**DEVIATION REQUEST
 AND DECISION FORM**

Project Name : GRANDVIEW PHASE 2 (PUDSP-23-006)
 Schedule No.(s) : 4200000475, 4200000474
 Legal Description : A TRACT OF LAND BEING A PORTION SECTION 21, AND A PORTION OF THE NORTHEAST
 QUARTER OF SECTION
 28, TOWNSHIP 12 SOUTH, RANGE 64 WEST OF THE 6TH/ PRINCIPAL MERIDIAN, EL PASO COUNTY,
 COLORADO

V3_ T intersection deviation.pdf Markup Summary

**LOCATION #1:
 ROONEY & EDENVALE**

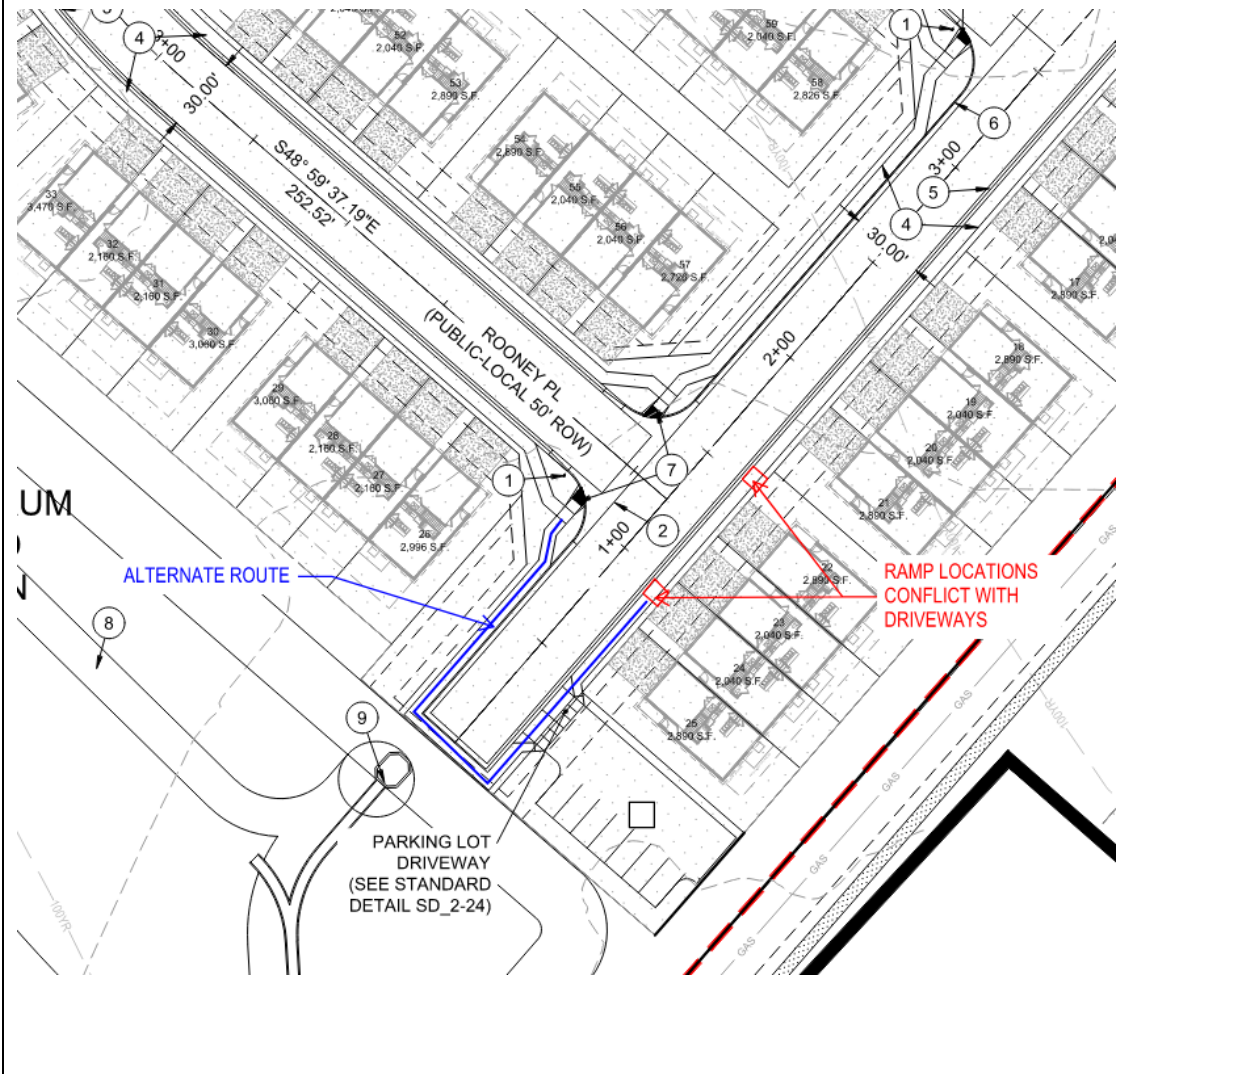
Intersection of Scone
 and Sligo needs to be
 addressed or ramps
 and crossing need to
 be added on Sligo

Please revise to four ramps per the criteria

LOCATION #2:
SCONE & DOWNPATRIC

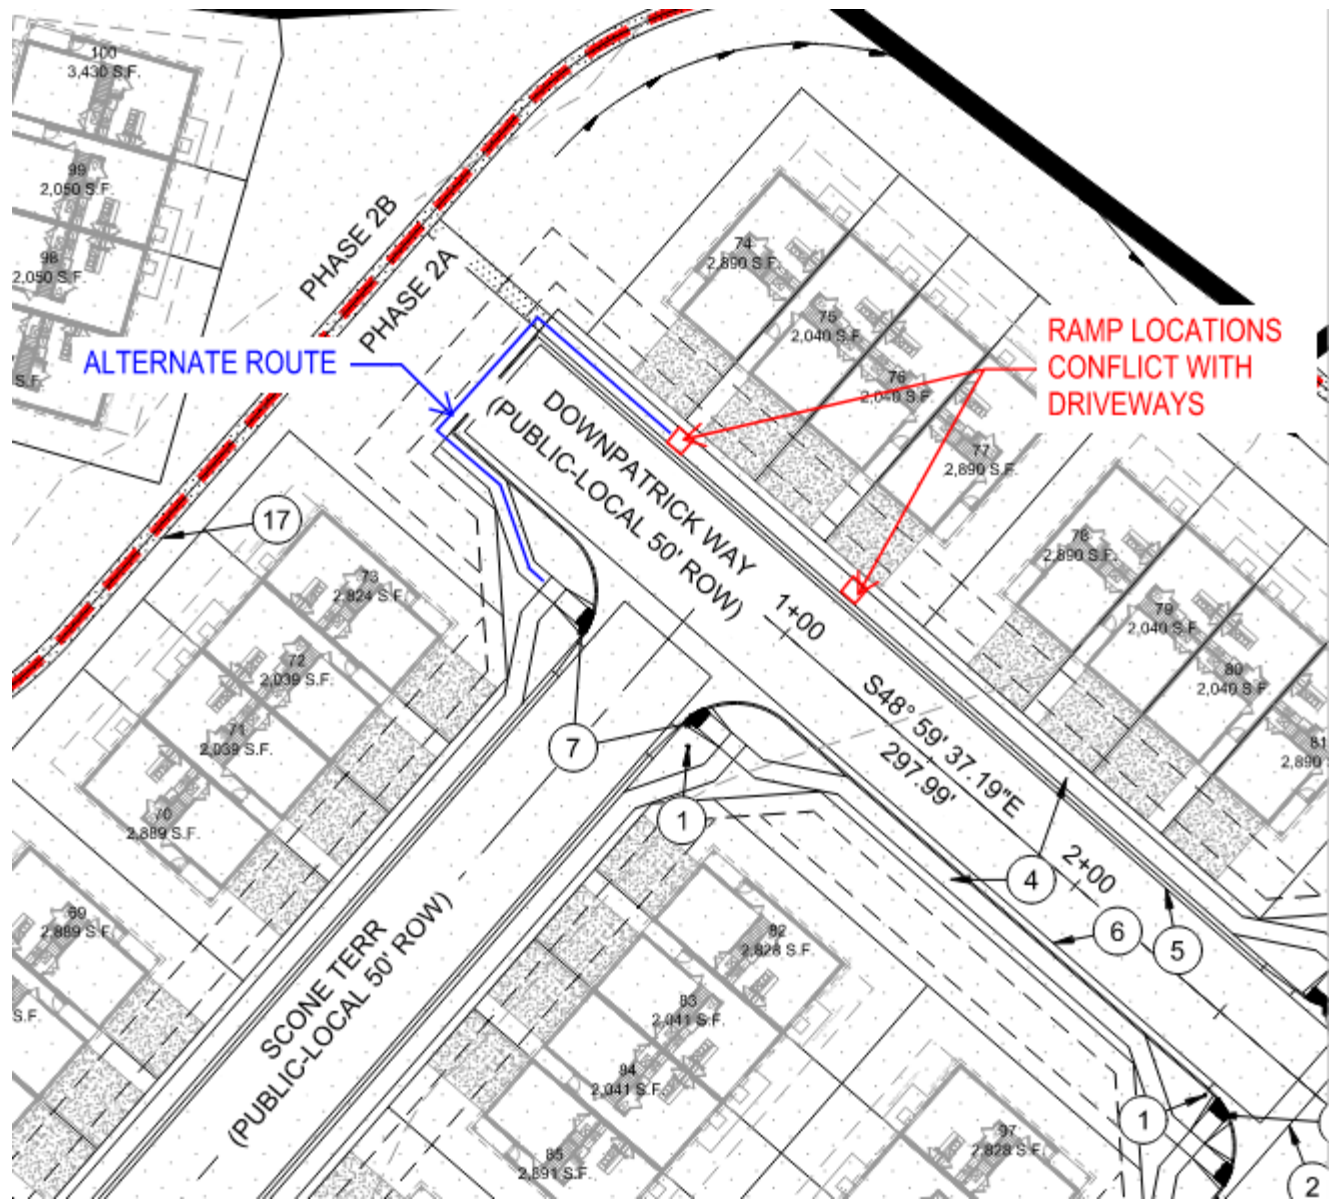
Please revise to four ramps per the criteria
